TOWN OF ERIE
BOARD OF TRUSTEES AGENDA ITEM
Board Meeting Date: February 28, 2017

SUBJECT:	GENERAL BUSINESS:
	A Sketch Plan Review of Flatiron Meadows Planning Area H
CODE REVIEW:	Erie Municipal Code, Title 10
PURPOSE:	A Sketch Plan represents a generalized land use plan and layout for the area proposed to be included within a subdivision. A Sketch Plan application is required to allow for an early, informal evaluation of a proposed subdivision before detailed planning and engineering work has occurred.
DEPARTMENT:	Community Development
PRESENTER:	Todd Bjerkaas PLA, Senior Planner

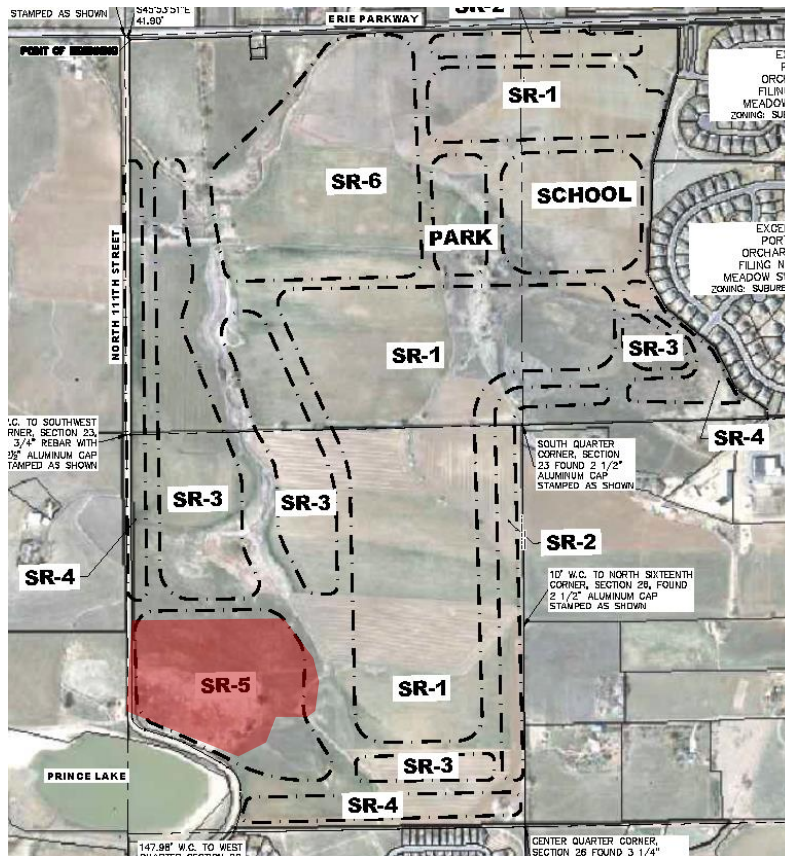
The Sketch Plan application proposes 118 units in the southwest corner of the Flatiron Meadows Subdivision in an area designated “PUD SR-5” within the Flatiron Meadows PUD Overlay Map Amendment No. 2 (below). The PUD does not set a maximum density for the SR-5 area but instead sets a maximum number of 132 dwelling units.

The sketch plan area is bound by drainage and open space areas to the south and east, single-family detached lots (SR-3 and SR-4) to the north which are currently in a Preliminary Plat Amendment application, and N. 111th Street and unincorporated Boulder County to the west.

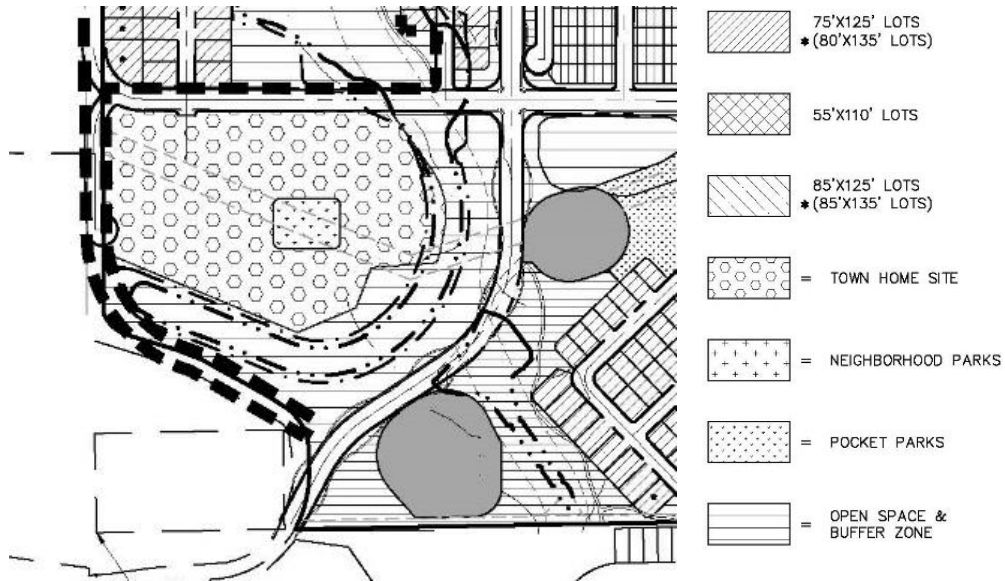
The development features single-family attached lot types in the configuration of alley-loaded paired homes. Most lots would face interior common green spaces or adjacent open space.

Only the north facing lots on the southern stretch of the loop street are oriented directly to a street. Two access points are proposed from N. 111th Street (which will be reconstructed) and form a loop road for access through the SR-5 area.

A Pocket Park, as required by the Preliminary Plat (see enlargement below), is located within this sketch plan at its southeast edge adjacent to open space. A local trail on the north side of the area would connect into the single-family detached lots to the north. That trail would also provide a trail connection to the east, across the drainage way, and to the newly constructed Spine Trail.
